project: General Interior Renovations of 250 College
St. Ground, 8, 9, 10, & 11th floors ADD # 01

CAMH RFP # 1175.23 date: 2023-08-30
HJA proj no: 22-48

This addendum forms part of the contract documents and is to be read, interpreted, and co-ordinated with all other parts. The cost of all contained herein is to be included in the stipulated bid price. The following revisions supersede the information contained in the original drawings and specifications issued for the above-named project to the extent referenced and shall become part thereof. Acknowledge receipt of this Addendum by inserting its number on the tender form. Failure to do so may subject bidder to disqualification.

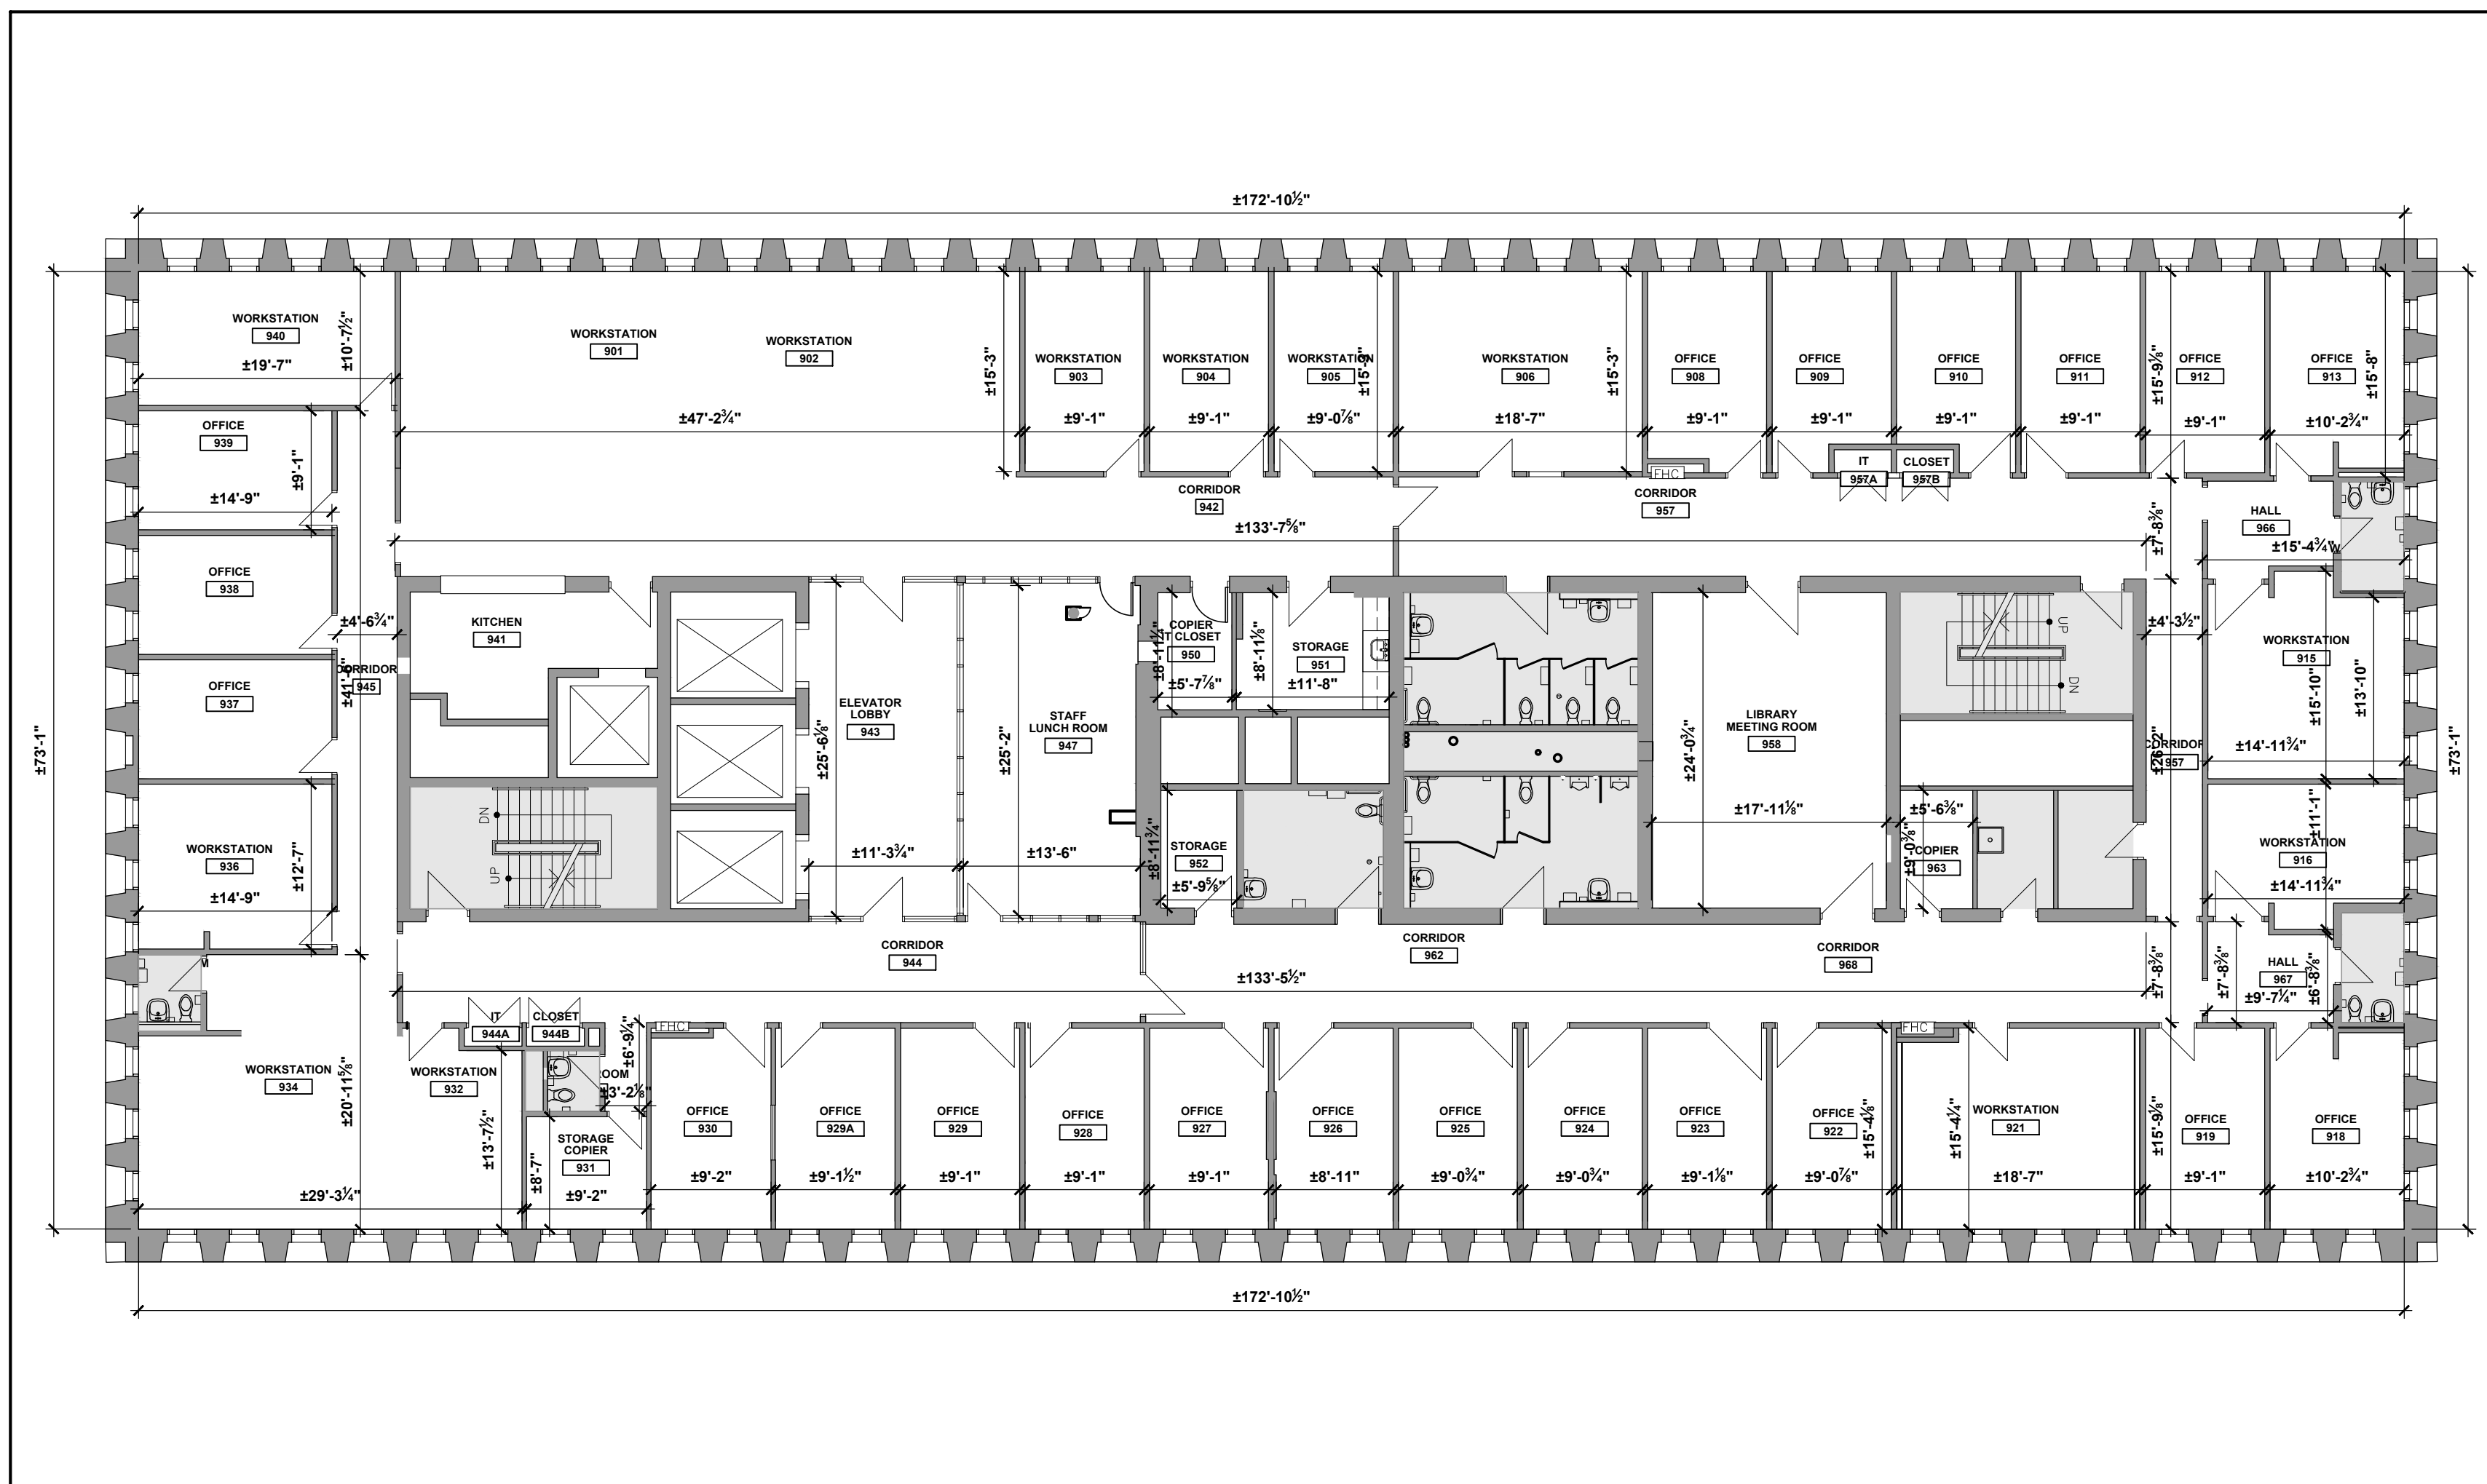
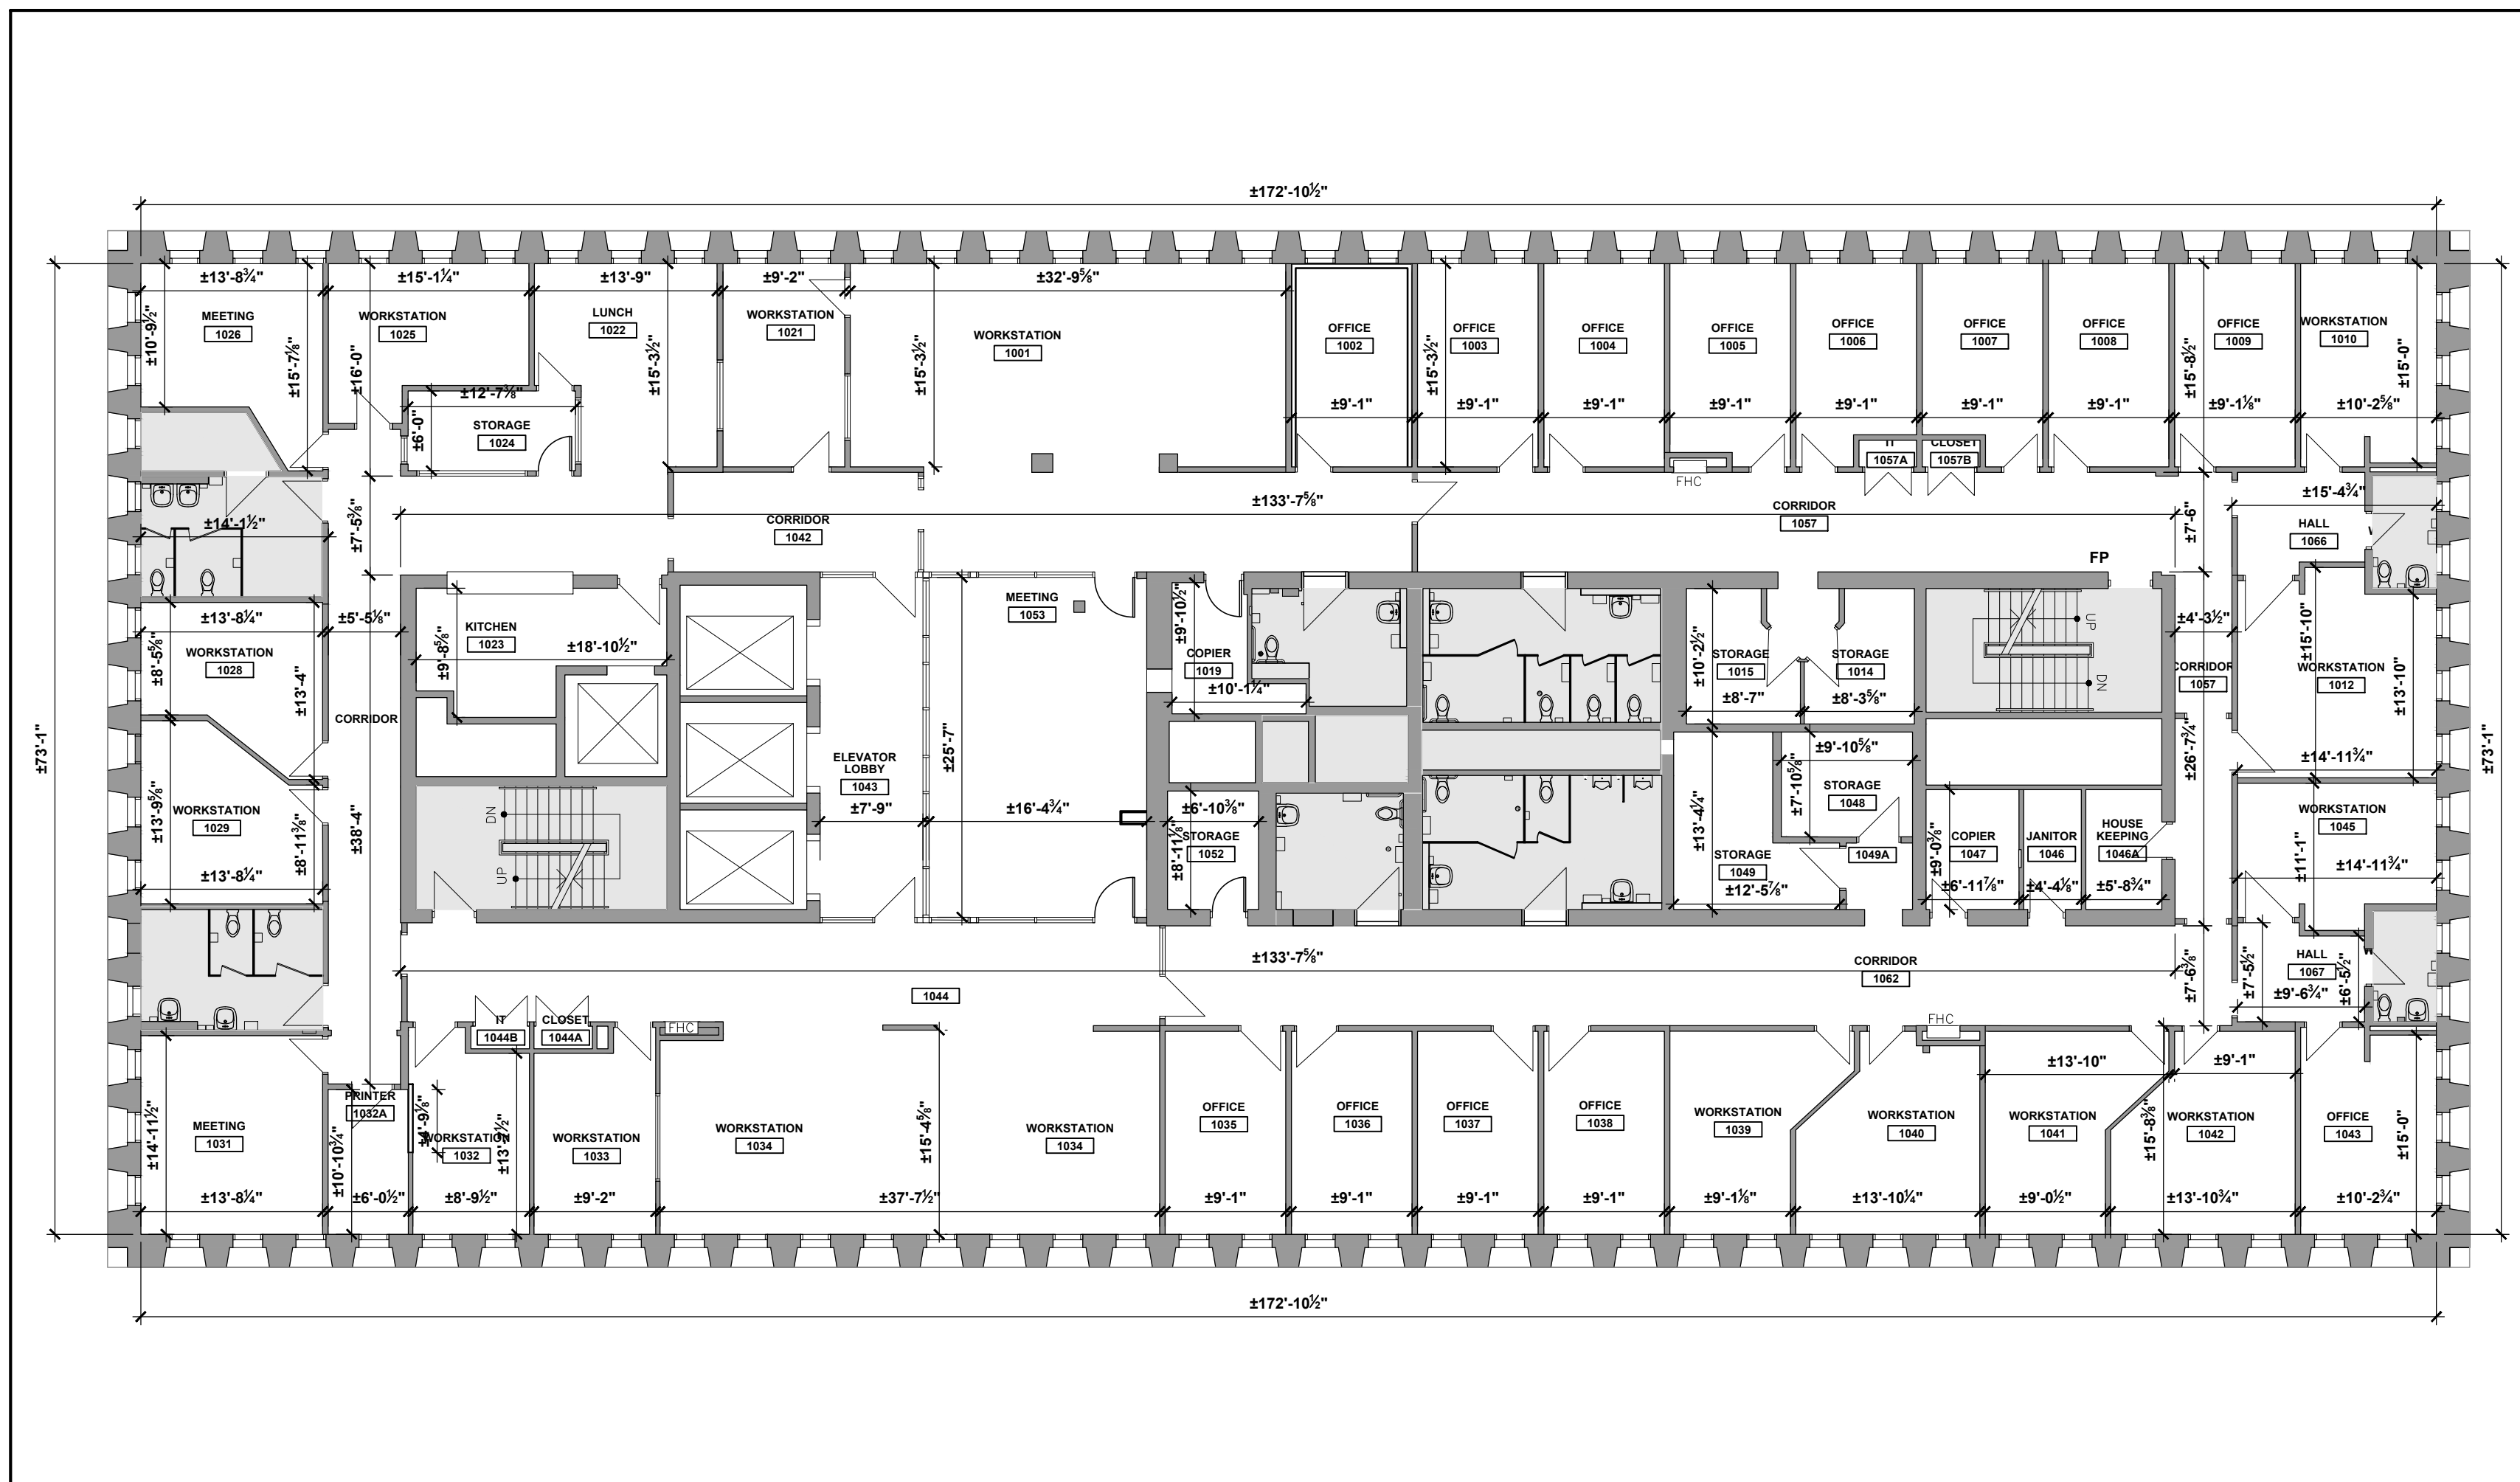
If the Consultants will not provide dimensions and the Owner is prepared to assume the risk associated with having Bidders determining the actual extent of the requirements please allocate no less than 5 business days for Bidders, with their selected Subcontractors and Suppliers, to have uninterrupted and free access to all areas subject to the proposed renovations so to measure each

room, space and corridor to complete the dimensioning requirements; this would allow Bidders a business day per floor plus an additional day for follow-up / supplemental review, to document all required measurements. Given the current indication of the initial date for the Mandatory Site Visit and the time requirement for Bidders to accumulate the required information please then allow the Bidders 2 business days to tabulate and distribute the supplemented Bid Documents and maintained the currently allowed 5 business days for Bidders to collect, tabulate and populate your RFI Form for submission through this portal. As such please revise Item 3.1.1 Timetable of the RFP to allocate the 5 business days for site review and measuring, 2 business days for tabulation and distribution of supplemental Bid Information, and 5 business days for review and assembly of questions into your RFI Form resulting in need for further revision to the date for final addenda and Bid Closing. Alternatively, please have the Consultants provide the missing information, specifically dimensions of all spaces, including provision of vertical dimensions including floor to floor heights, and the re-issue the updated and complete Bid Documents.

Response: Drawings A-500 and A-501 dated Aug 28, 2023 are issued with this addendum. These drawings provide overall approximate dimensions and areas of the areas of work. These drawings are issued for the express purpose to enable bidders to perform approximate takeoffs to provide work and materials requested. Verification of actual as-built site dimensions for all aspects of the work will be the responsibility of the successful bidder.
